ASU CREST Center

Jonesboro, Arkansas

Pre-Bid RFIs

5/25/2026

③ CEILING DETAIL
1 1/2" = 1'-0"

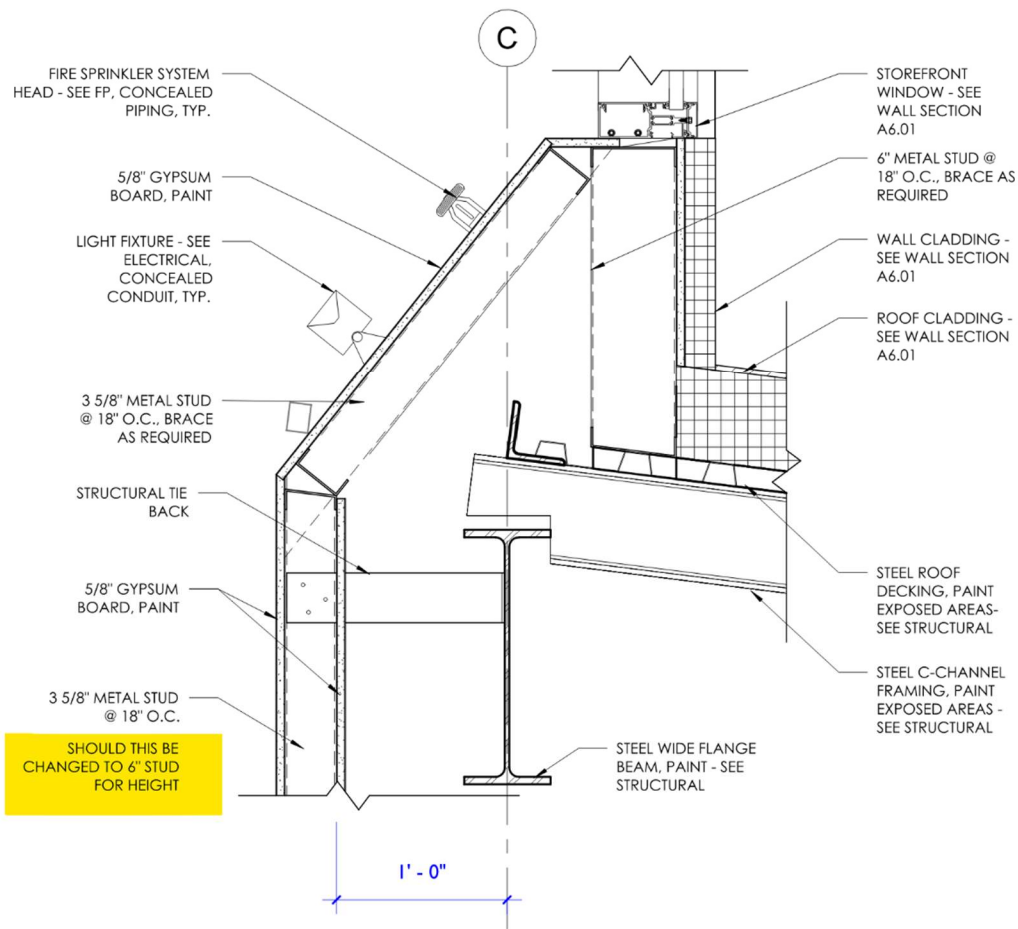
13. RE: 3/A2.31 (image below) - Does this need to be a 6" stud? **The 3 5/8" is good (since it is strapped back).**
